Subject: University of Florida Training Reactor (UFTR) License Renewal (TAC NO. ME 1586),
DOCKET NO. 50-83

Enclosed is a revised Technical Specifications (TS) in support of our application for renewal of Facility Operating License No. R-56 for the University of Florida Training Reactor (UFTR). Enclosed is also a spreadsheet providing justification for the changes considered in the revised TS.

APPENDIX 14.1

TECHNICAL SPECIFICATIONS

Figure 6-1 UFTR Organizational Chart

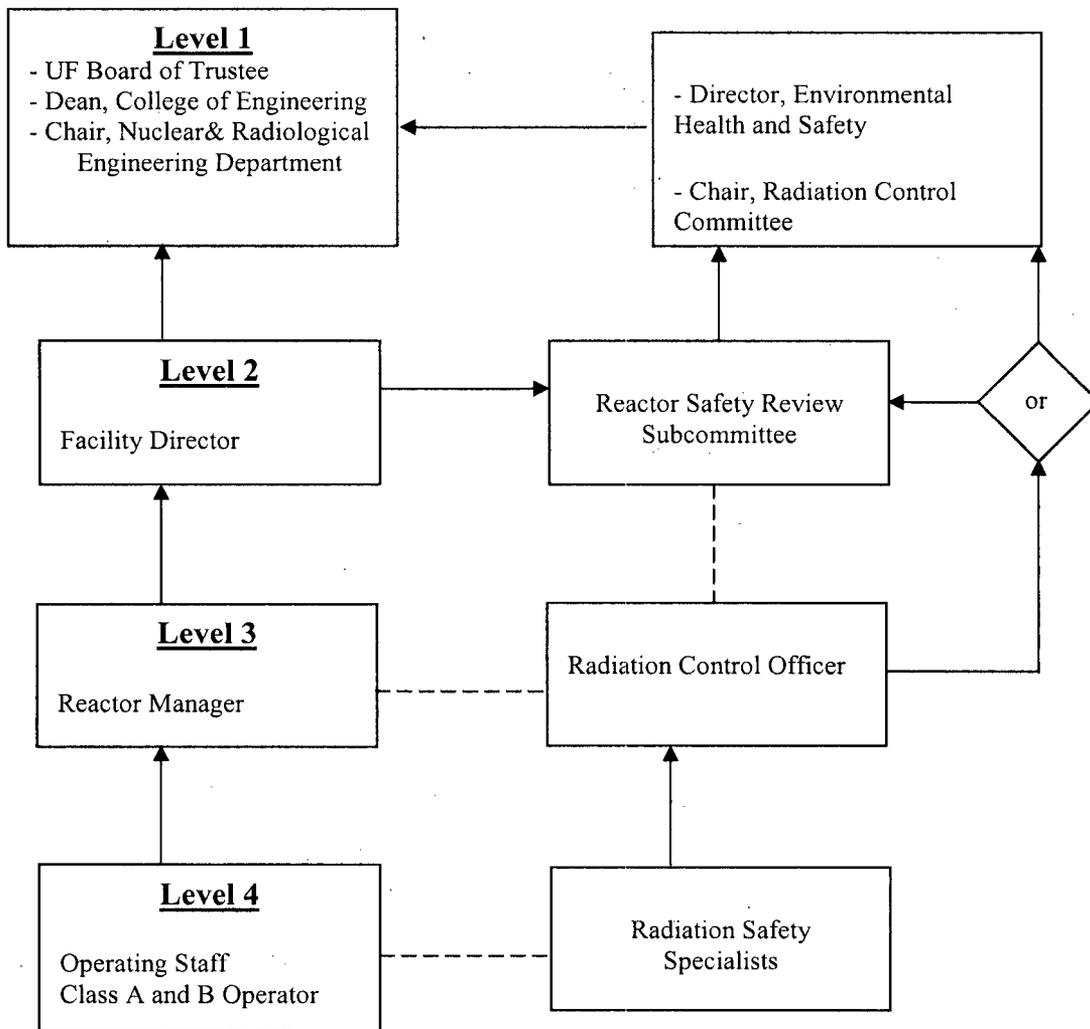
171	5.3	5.3 and 5.4	C	Merge sections 5.3 and 5.4 into new 5.3 with core description first, to remain consistent with ANSI 15.1
172		5.3	C	Adjusted first sentence to clarify fuel enrichment
173	5.3	5.3		Marked in yellow... remove because in license?
174		5.5, 5.6, 5.7	R	Removed sections, found in UFSAR, to remain consistent with ANSI 15.1
175	5.4	5.8	C	old 5.8 now 5.4 to remain consistent with ANSI 15.1, change keff to 0.9
176	5.4	5.8.1 and 5.8.2	C	All content removed and replaced with statement the fuel stored IAW UFTR Physical Security Plan.
177	5.4	4.2.7(1)	A	Added, it came from section 4.2.7(1) because it was determined to be part of facility design.
178		6.1	R	Remove definitions, RO and SRO are in definitions, to remain consistent with ANSI 15.1
179	6.1.1	6.2.1	C	Replaced "Vice-President.." with level 1 admin.
180	6.1.2	6.2.2	A	Add sentence at end to ensure all scenerios are covered.
181		Figure 6-1	C	Moved Figure 6-1 to end of section 6, ease of use.

211	6.7.2.(3)c	6.6.2(3)c	C	Moved note out of parentheses for easy reading.
212	6.7.2.(3)d	6.6.2(3)d	C	units and inequality to remain consistent throughout specs
213		6.6.2(3)g	R	remove, redundant with all in section 6.6.2 and section 4
214	6.7.3(1)	6.6.3(1)	C	remove level 3, to remain consistent with ANSI 15.1
215	6.7.3(2)	6.6.3(2)	C	change end of sentence, assuming SAR and conversion report will be merged
216	6.8	6.7	C	Beginning of last sentence "Recorder charts" replaced with "Records", to clarify
217	6.8.1	6.7.1	C	(1) change time to 3 years to ensure NRC inspection cycle included for oversight, (3) additions made for clarity
218	6.8.2	6.7.2	C	Change to remain consistent with ANSI 15.1
219	6.8.3(4)	6.7.3(4)	C	replace "updated" with "current", clarify the statement
220	6.8.3(5)		A	Added (5) to remain consistent with new 6.8.1(3).
221	Figure 6.1	Figure 6.1	C	clean and clarify, no change in responsibilities
